**RE: TransAlta Rail Upgrade
Request for Waivers
CDG Project No. 05002-01**

PROJECT: TransAlta Generation LLC
Rail Upgrade
Centralia Operations
CDG Project No. 05002

SUBJECT: Design Variances and Exceptions

Ash Loadout Facilities, Sta. 21+70.07 foreground; Sta. 20+69.88 background.

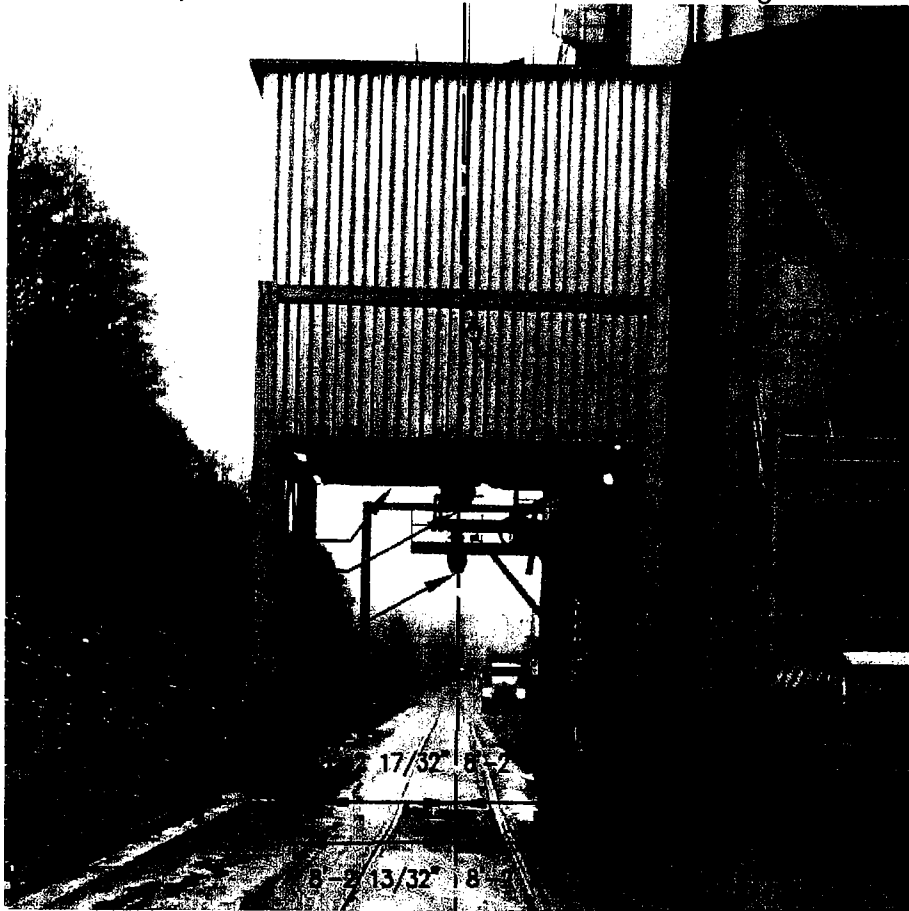
The structures in the center of the photograph below illustrate the ash loading facilities. In the foreground is the enclosure and chute at Sta. 21+70.07. As the train enters the enclosure at Sta. 21+56.54, the lower edge of the enclosure, having a clearance of 17'-8 7/8" does not meet the 18'-00" required by the State of Washington for a train traveling through a building, thus a waiver will be required. Increasing the clearance would require replacing the structure at significant cost.

The horizontal clearance required by the State of Washington when in buildings is 8'-6". There are four footings which encroach on this requirement. At Sta. 21+57.48, the horizontal clearance is 8'-2 7/8" Left (picture right) and 8'-2 17/32" Right (picture left), and at Sta. 21+81.96, horizontal clearance is limited to 8'-3 15/32" Left (picture right) and 8'-2 13/32" Right (picture left). These foundations support the enclosure around the primary ash loadout facility. Adjustment to these footings would require replacing the enclosure at significant cost. A variance will be required due to the narrow width between foundations.

The clearance under the primary loading chute at Sta. 21+07.07 is 15'-8 7/8". Again using the BNSF Locomotive Clearance Diagram (Dwg. No. 903024B) as a reference, 16'-1 15/16" is needed to clear the locomotive. The Plant is able to adjust the chute, increasing the clearance to 17'-0", sufficient to clear the locomotive, but still requiring a waiver. Adjusting the loadout to meet the State minimum requirement would require reconfiguration of the entire loadout structure.

The secondary ash loadout facility (background of picture below, Sta. 20+69.88) also presents a clearance problem, however the entire structure is being removed.

TRANSALTA - CENTRALIA PLANT
RAIL FACILITIES UPGRADE
PLAN AND PROFILE
STA 71+50 THRU 77+00

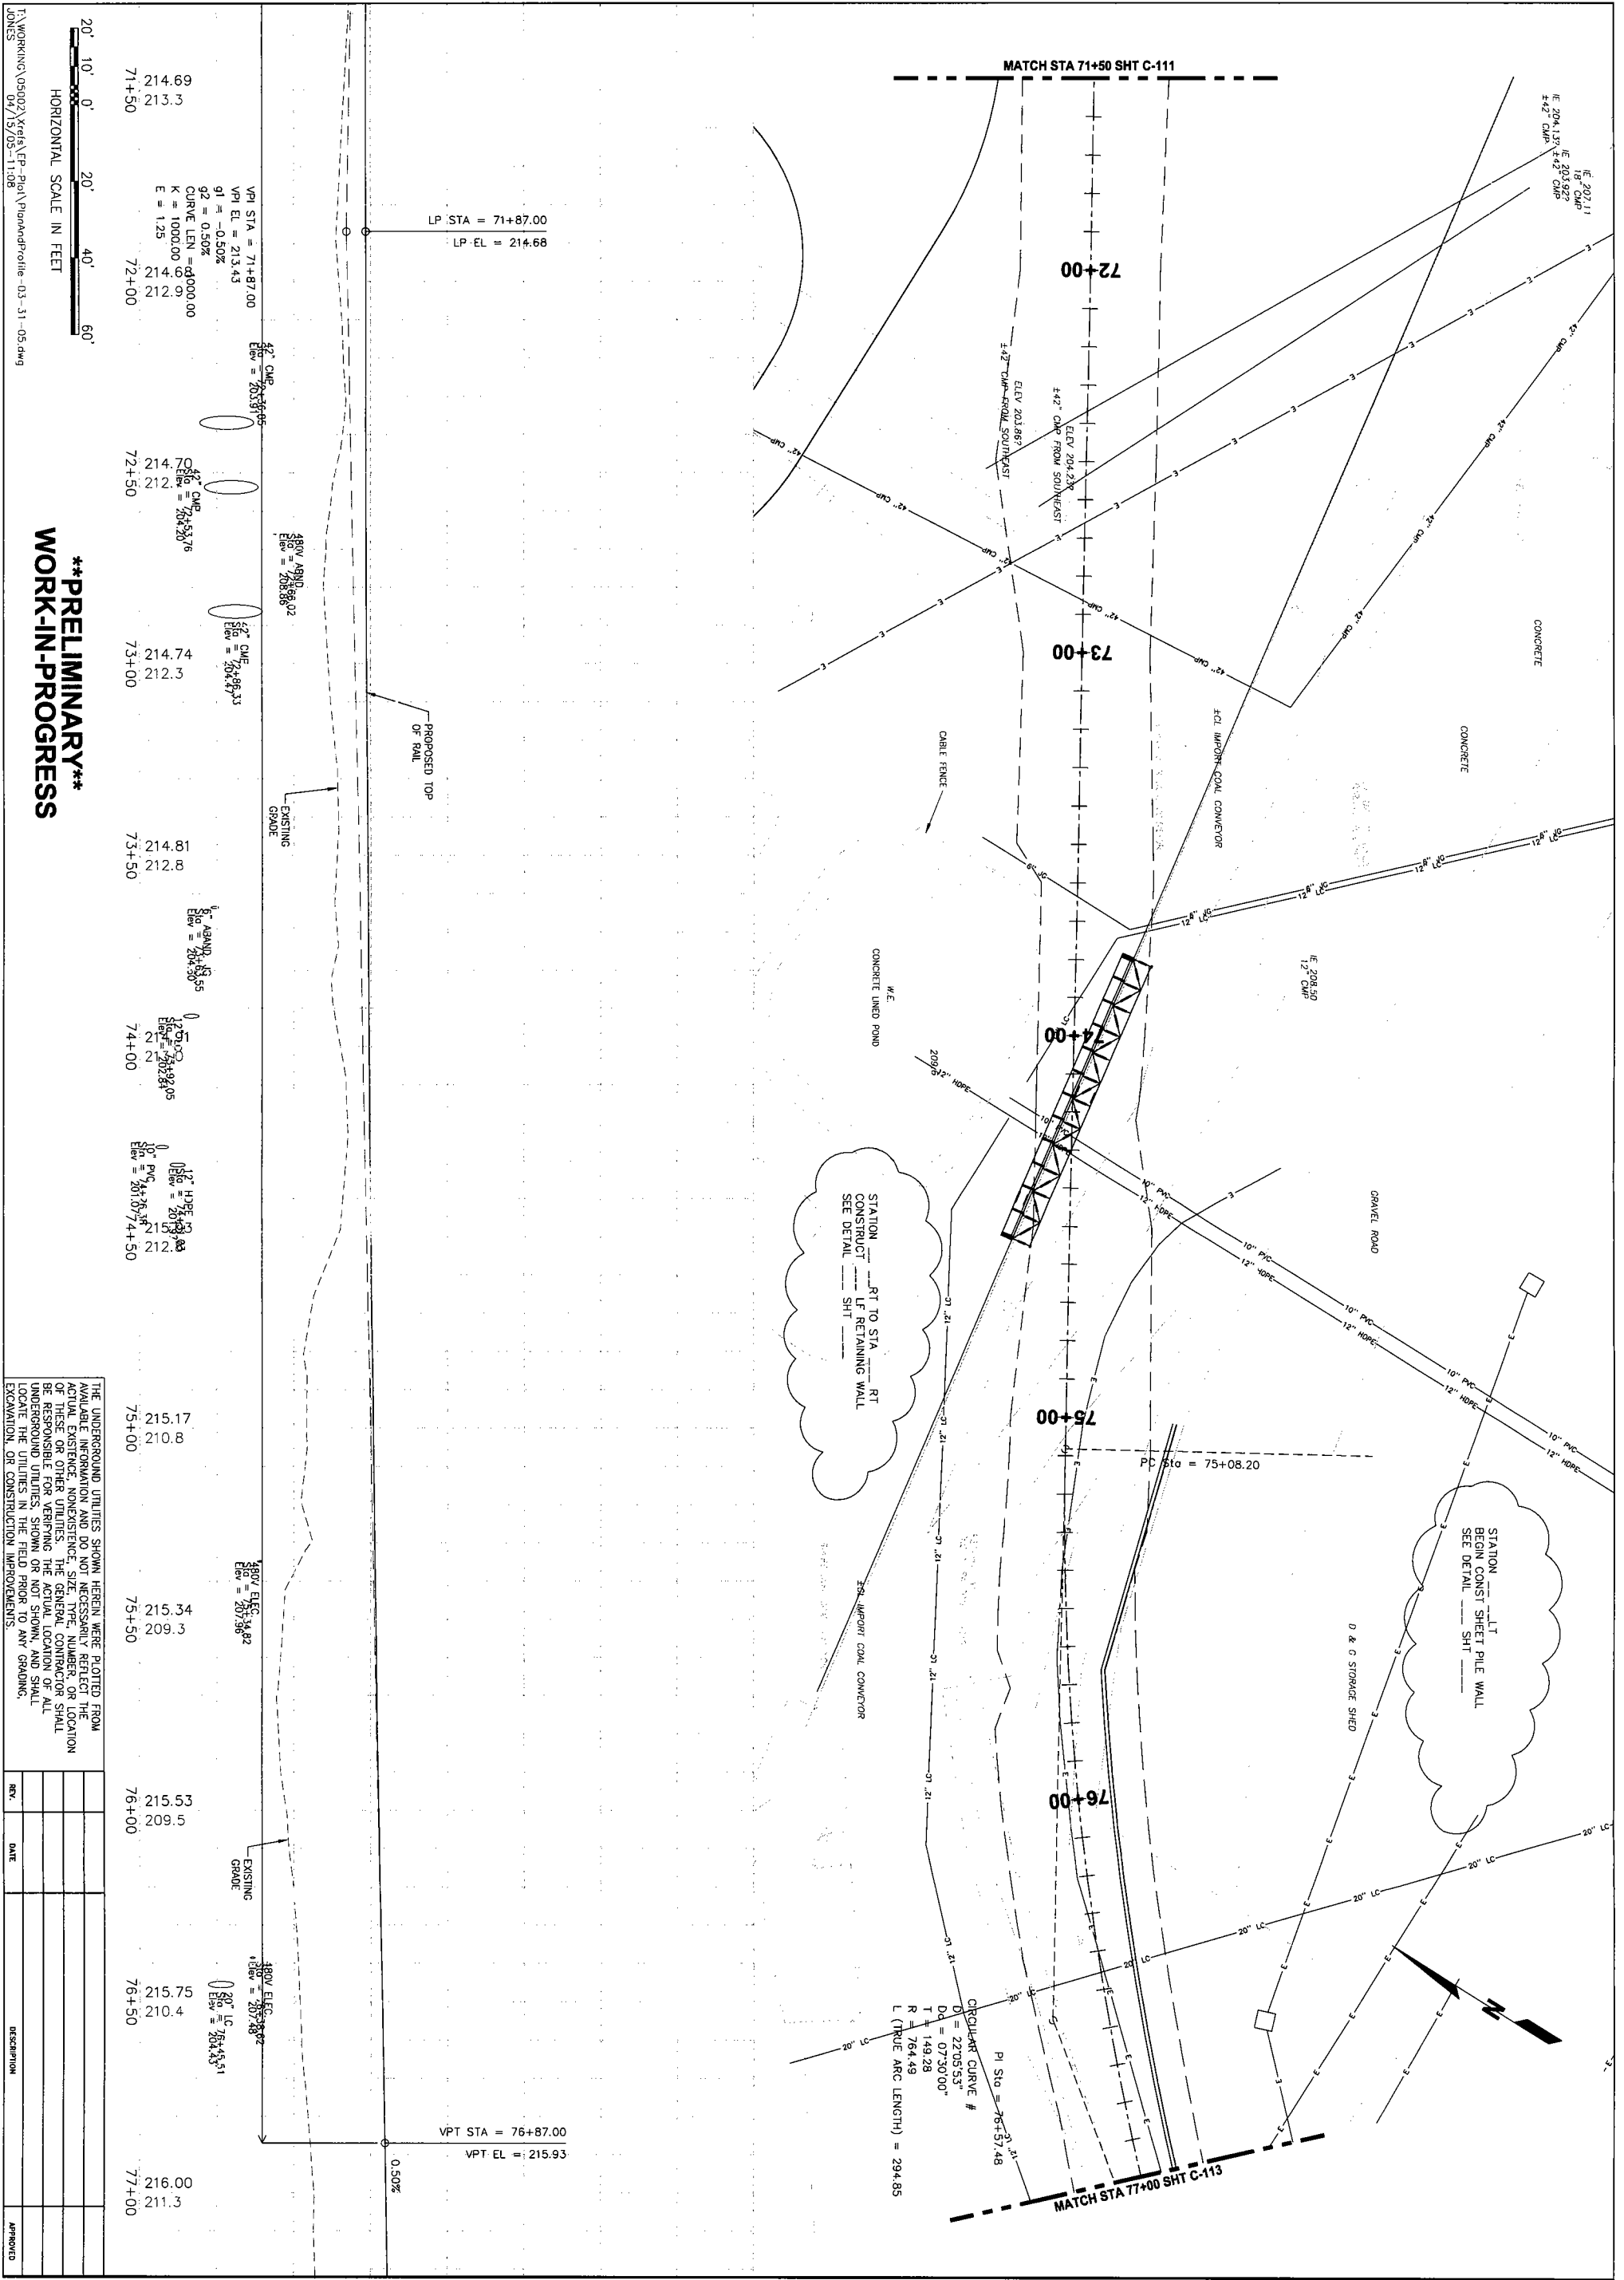
6. Sta. 74+16.50: Vertical clearance 19' 2 3/4"

At Sta. 74+16.50, a conveyor will cross the alignment. Due to the close proximity of the tail pulley, there are limitations to the degree of vertical curvature with which the conveyor belt can withstand before displacing from the conveyor. The maximum vertical clearance achievable is 19' 2 3/4", short of the required 22'-6" required by the State of Washington for a bridge, but above the 18'-0" requirement for passage through a building. The grade on the track is set to allow for positioning of the cars at the Coal Unloading Facility, and is not able to be changed without replacing a significant length of track, two switches, and entire Coal Unloading Facility, thus we are requesting a waiver for this bridge.

Secondary Ash Loadout

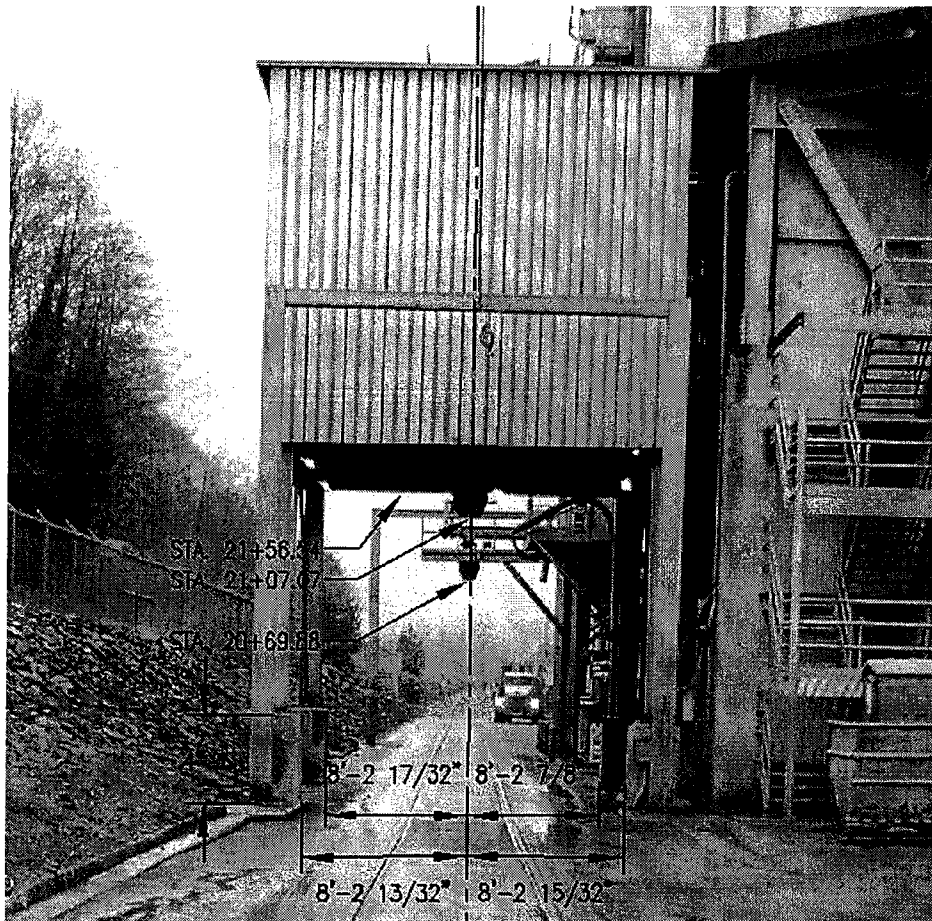
The sketch below illustrates the first of two ash loading facilities existing at the site. The clearance under the secondary loading chute at Sta. 20+69.88 is 15'-10 13/16". Using the BNSF Locomotive Clearance Diagram (Dwg. No. 903024B) as a guide, 16'-1 15/16" is needed to clear the locomotive. The Plant is able to adjust the chute, increasing the clearance to 16'-10", sufficient to clear the locomotive, but still requiring a variance. Adjusting the loadout to meet the minimum requirement would require reconfiguration of the entire structure. The bollards shown in the sketch are for illustrative purposes only and will be removed as part of this project. A concrete barrier, the face of which will not encroach on the minimum clearance requirements, will encase and protect the supports currently protected by the bollards.
